University of South Carolina
Softball Stadium Construction
Columbia, SC

State Project No. H27-6088-MJ
Architect's Project No. 11.122.00
Addendum No. 2

April 24, 2012

ADDENDUM NO.2

SK-P-02

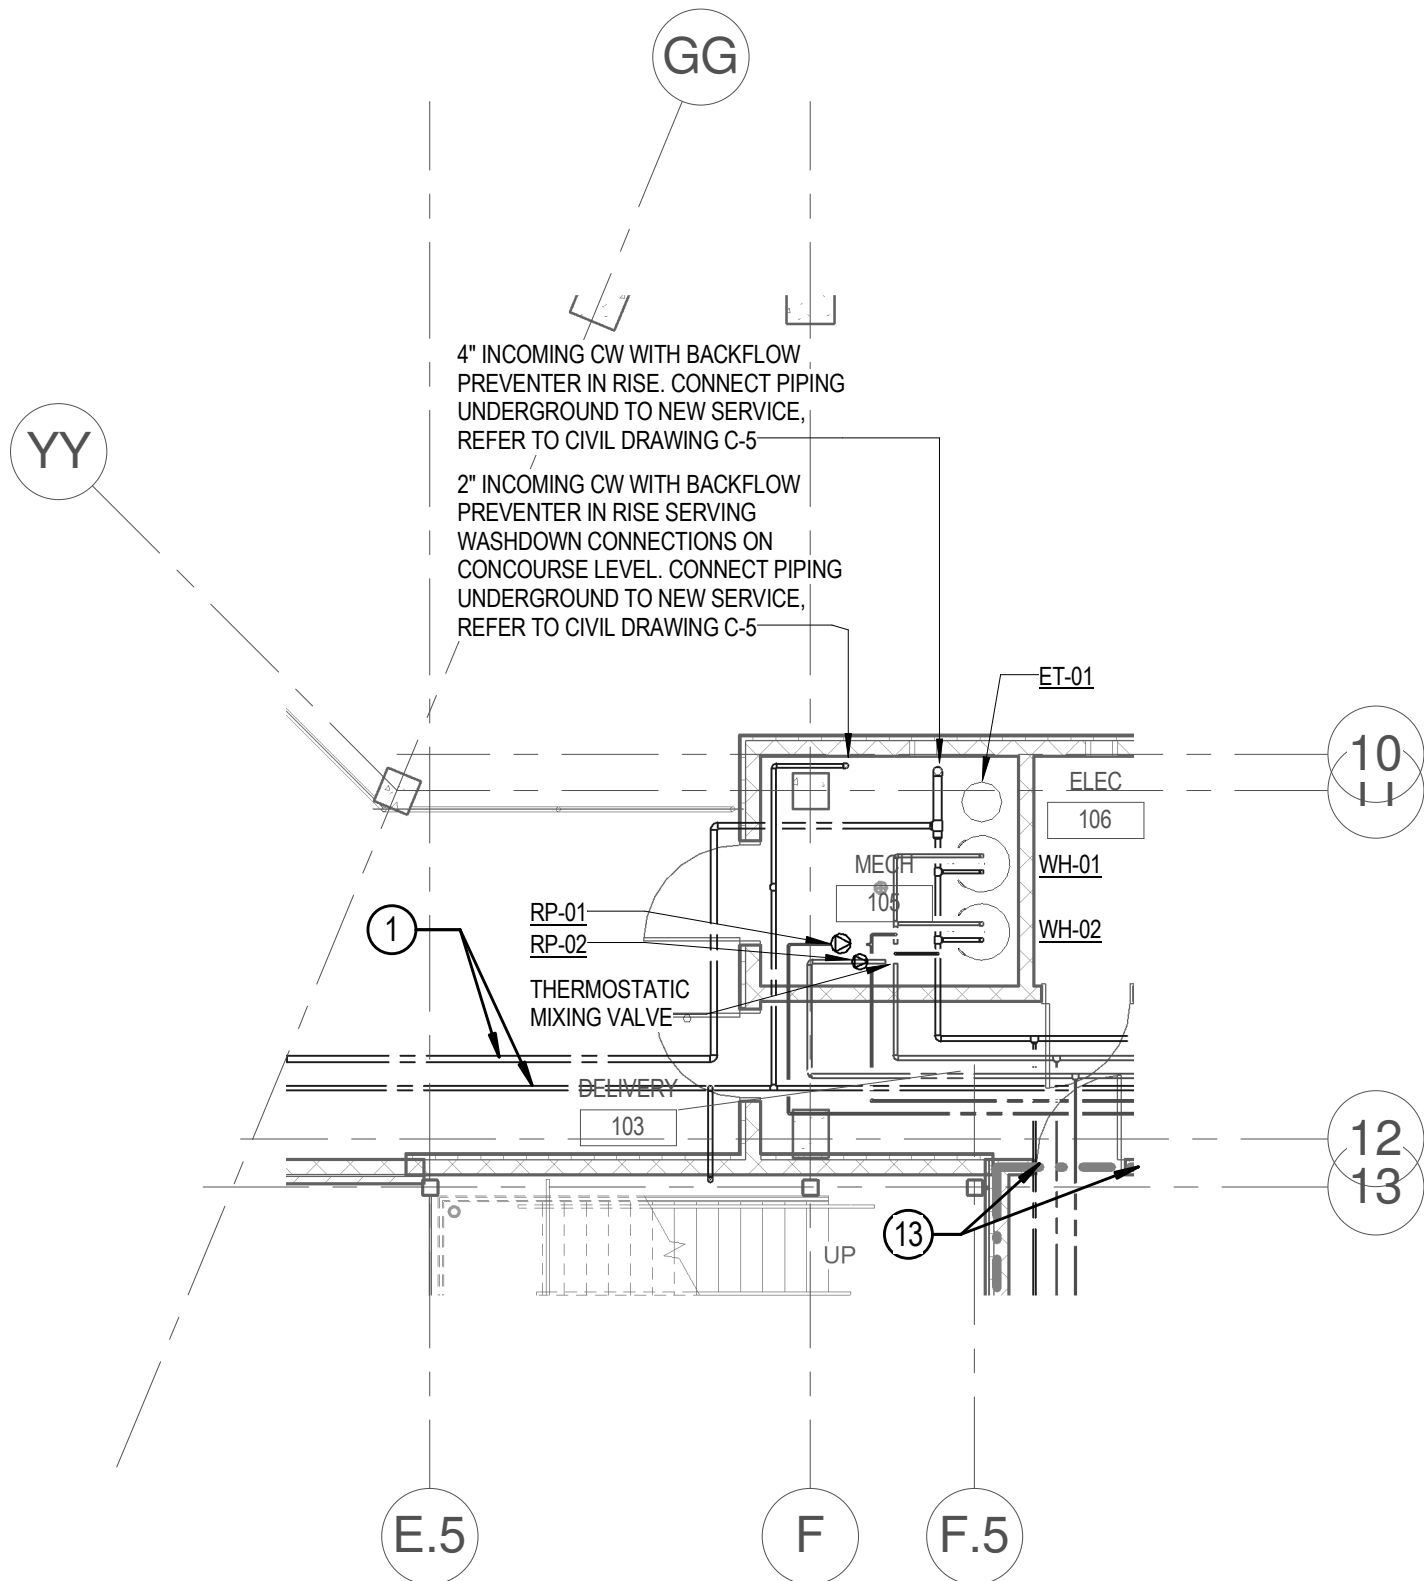
19. Reference drawing P201: Domestic water lines underground have been noted to refer to connection point on civil drawing C-5 as shown on sketch SK-P-02.

SK-E-01

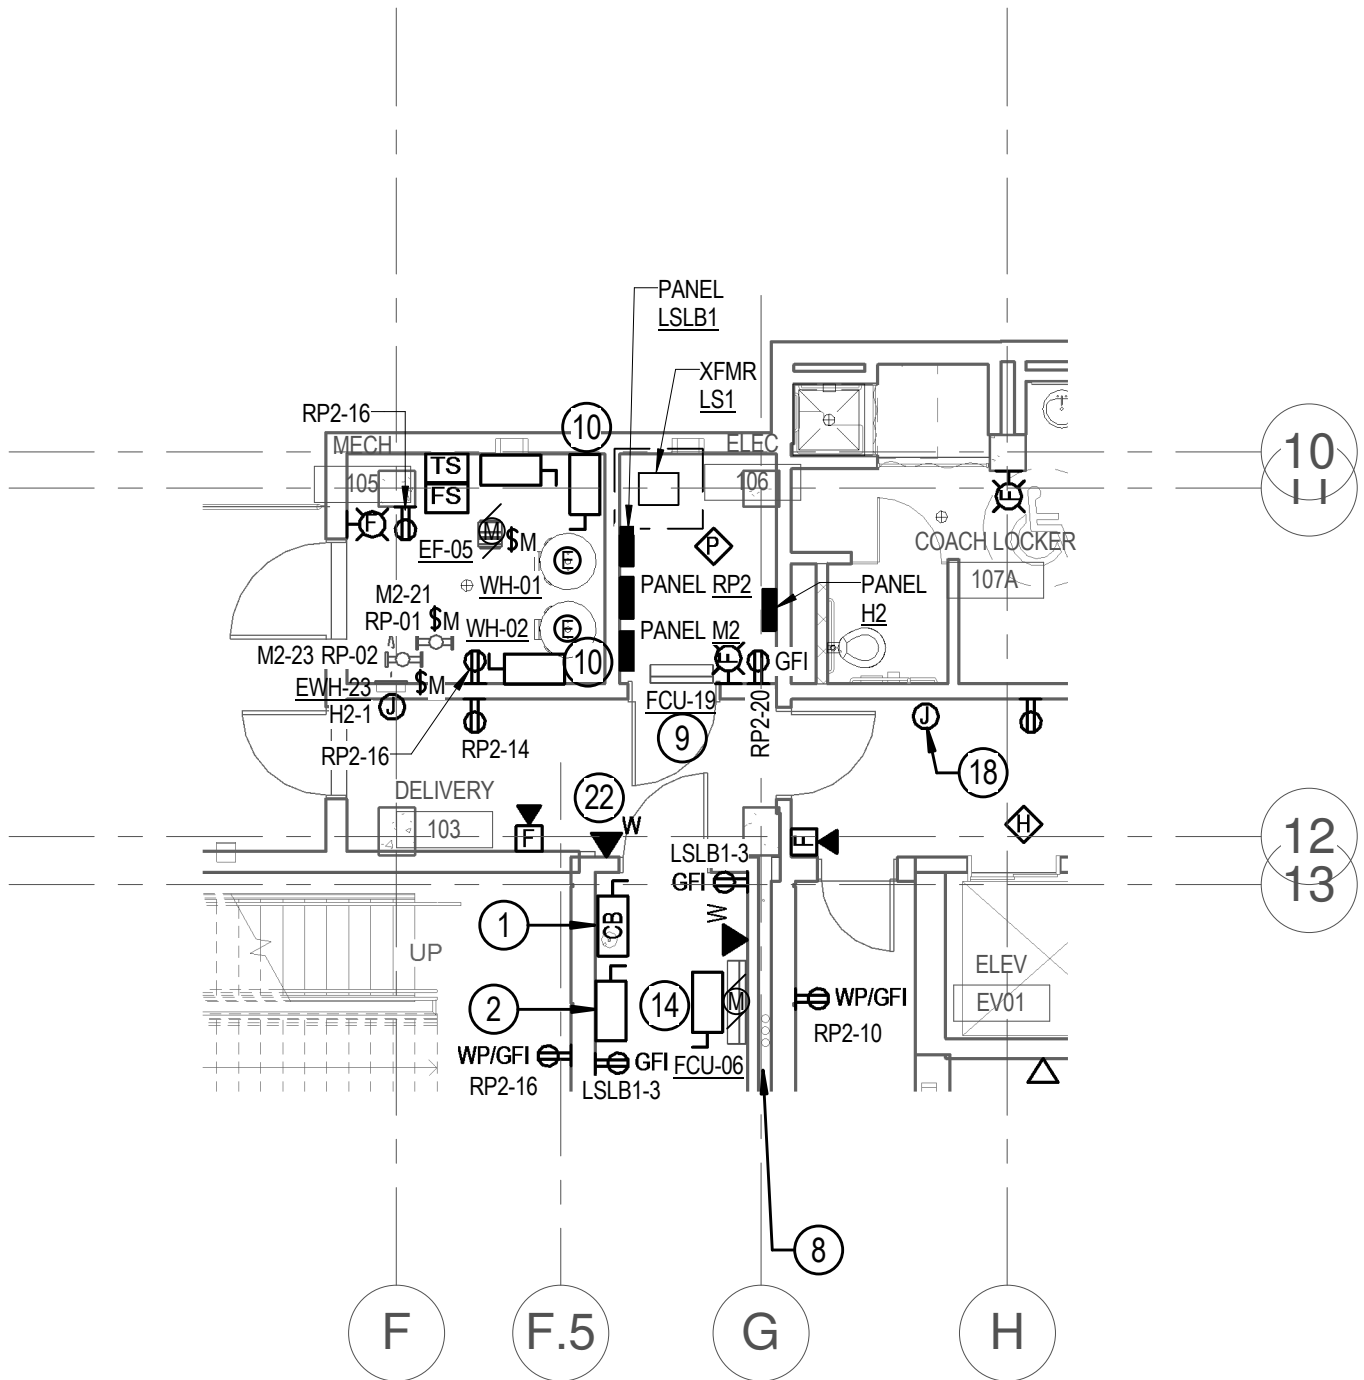
21. Reference drawing E101: Add ceiling mounted smoke detector to Elec 106 as shown on sketch SK-E-01.
